National Mission for Clean Ganga- Development, Rehabilitation with
Operation & Maintenance of STPs at Kanpur under Hybrid Annuity based PPP mode
Shah Technical Consultants Private Limited

Sub: **HAM Kanpur: PE Inspection Report for 5 MLD STP Shuklaganj**

SITE INSPECTION REPORT - 05 MLD STP AT SHUKLAGANJ

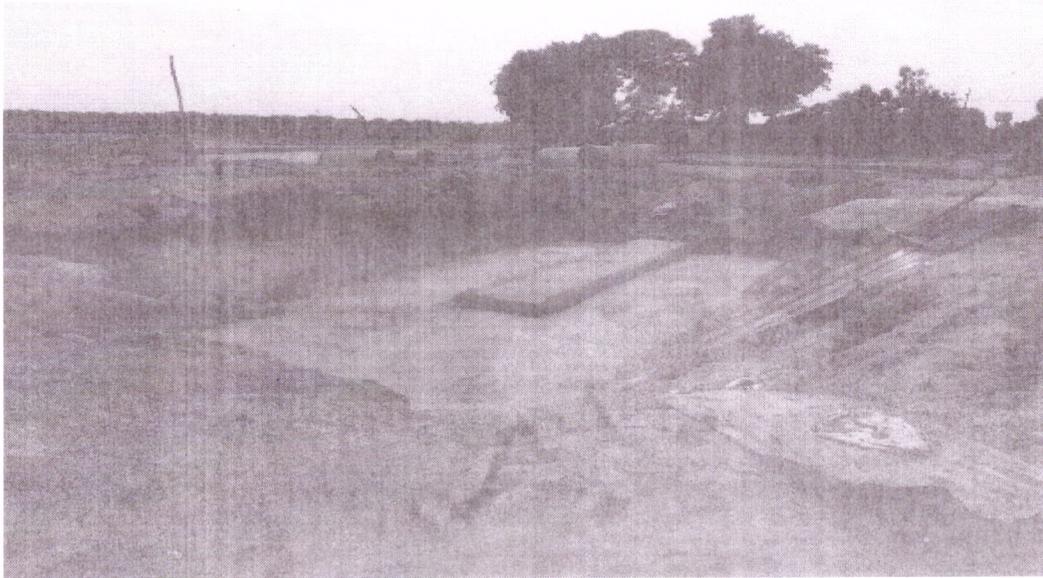
Compliance of COVID 19 protocols like wearing face masks, installation of hand sanitizer units etc. were not followed at the site. Workers were also not found wearing PPE's like Ear Plugs, Goggles, Hand gloves and Safety helmets. Disinfection spray fogging is being done in labour camps. Personal screening and awareness program are implemented. It is advised for procurement and usage of the PPE usage during work by workers, staff and visitors.

I&D Structure Location

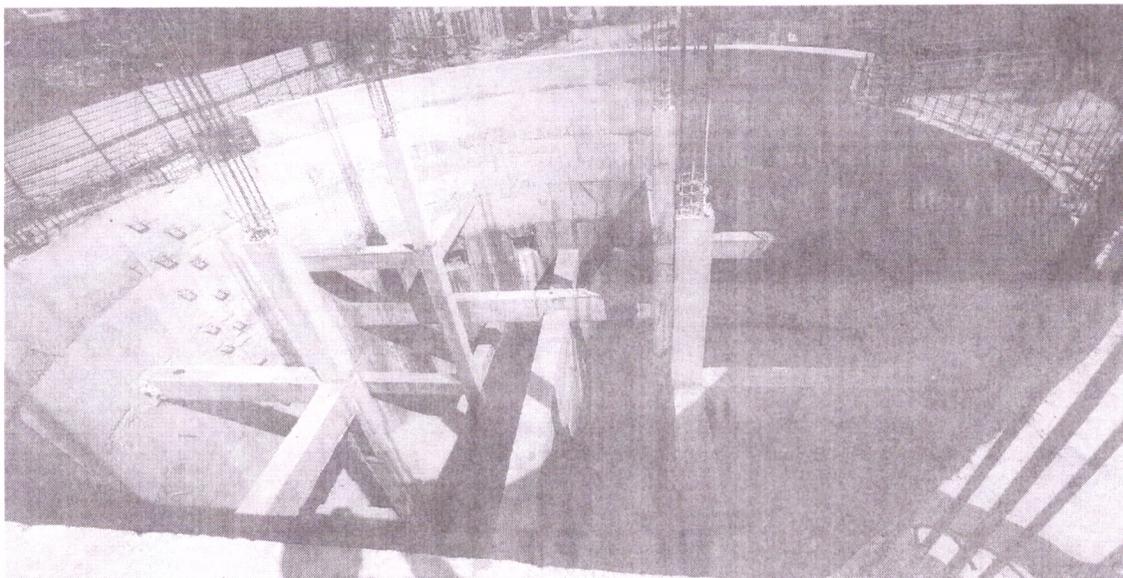
- i. **I&D Structure:** Work of I&D is very slow. Till date only excavation and PCC work has been done. It is to be noted that safety precautions are not followed by KRMPL. Excavated sites should be fully covered by hard barricading.

MPS wall casting work done

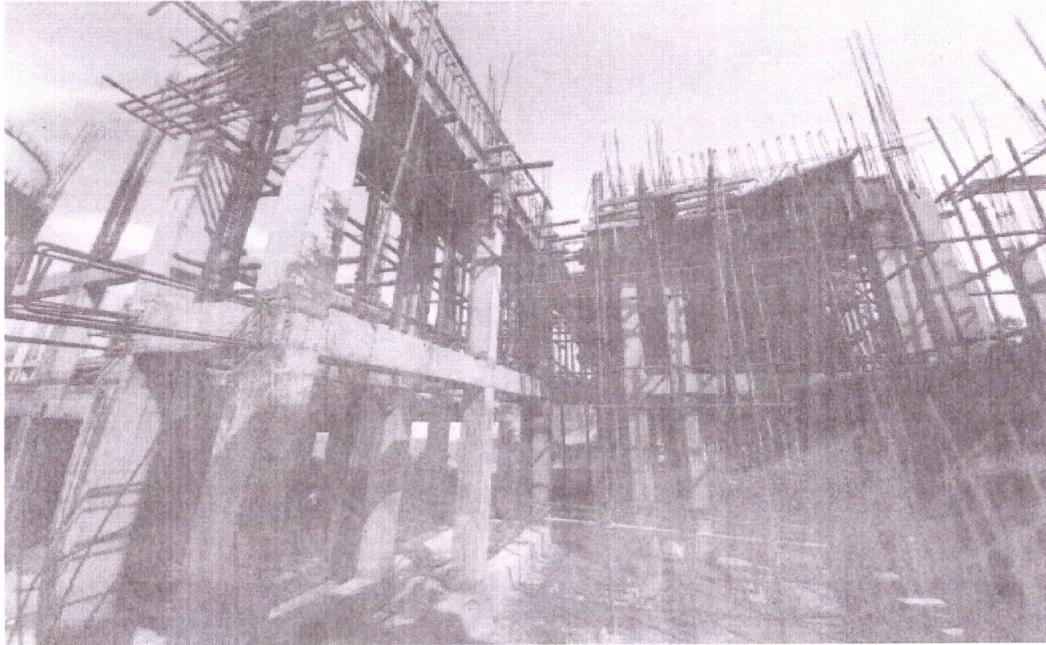
- ii. **Sewer System:** KRMPL (900mm dia) 85% laid out of sewer line without Approval Drawing and design, Ref letter STC letter no 1652 and UPJN letter.
- iii. **Main Pumping Station (MPS):** At inlet chamber, step arrangement and proper footrest have not been provided. MPS wall casting up to base slab done and cleaning in progress. KRMPL needs to do hydro testing with clear water as per CEPHEEO MANUAL and IS code 3370 in presence of UPJN & STC, before grinding and tar coal epoxy work.

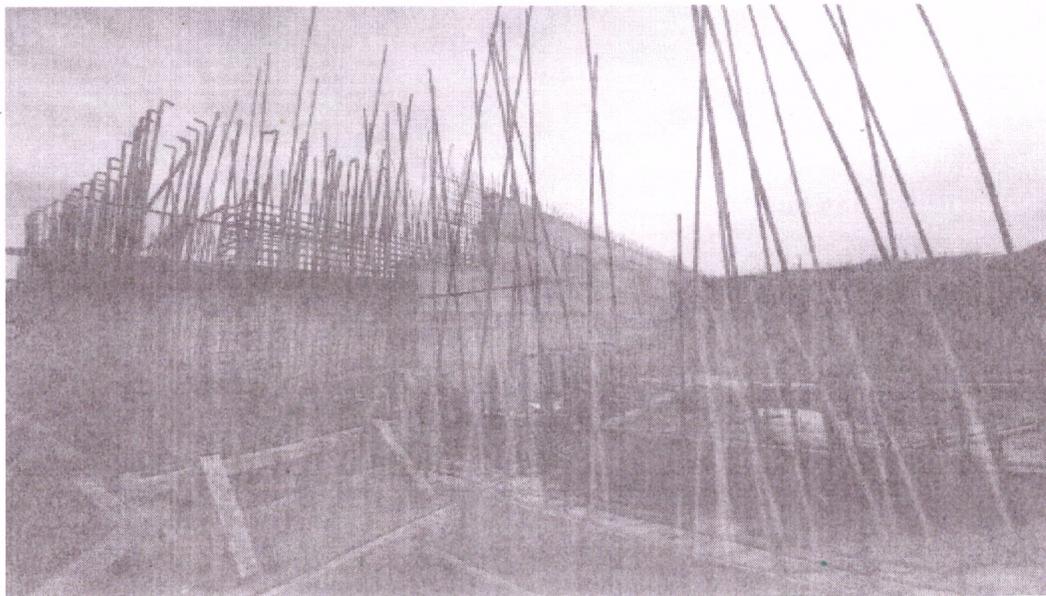
- iv. **Primary treatment unit (PTU):** Alignment of most of the Columns is not straight, bulged twisted & not in Plum bob, improper covers provided, top of Column wrongly smoothly finished & Column edges bend. Most of Steel is corroded. PTU, Column work completed and slab shuttering and reinforcement work in progress.

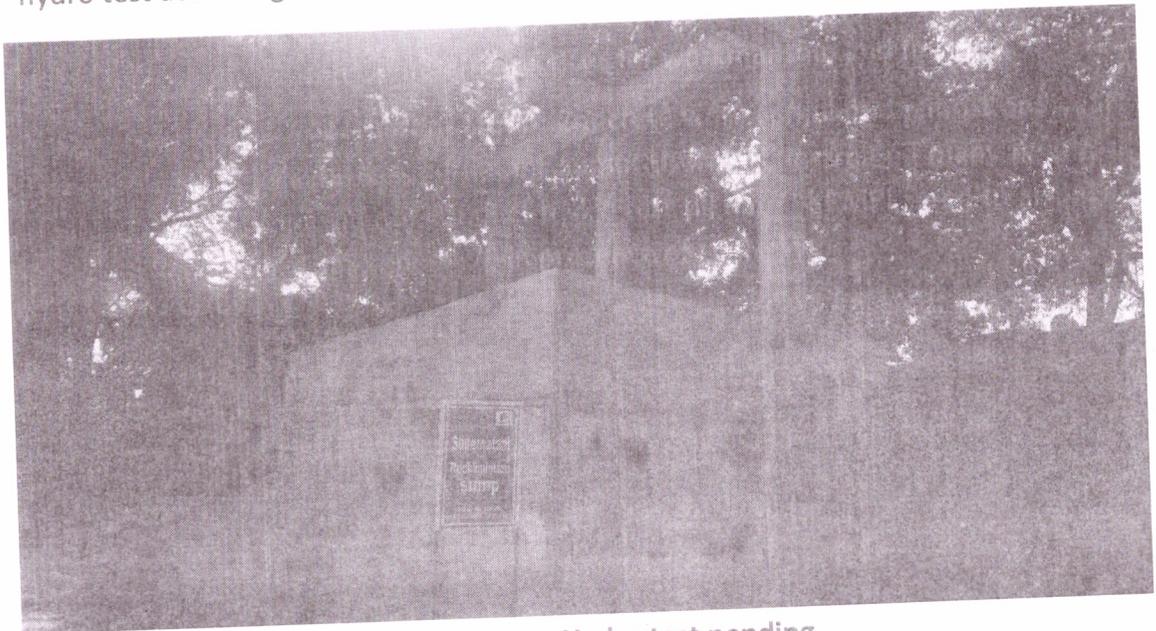
- vi. **CCT & Building:** Brick work is almost completed in Chlorination building. Improper brick joints found in brick masonry. Brick masonry has very large joints. PE noted that third class bricks have been piled up at the site. PE instructed KRMPL to not use

this type of brick and to remove third class brick from site immediately. KRMPL agreed for the same.
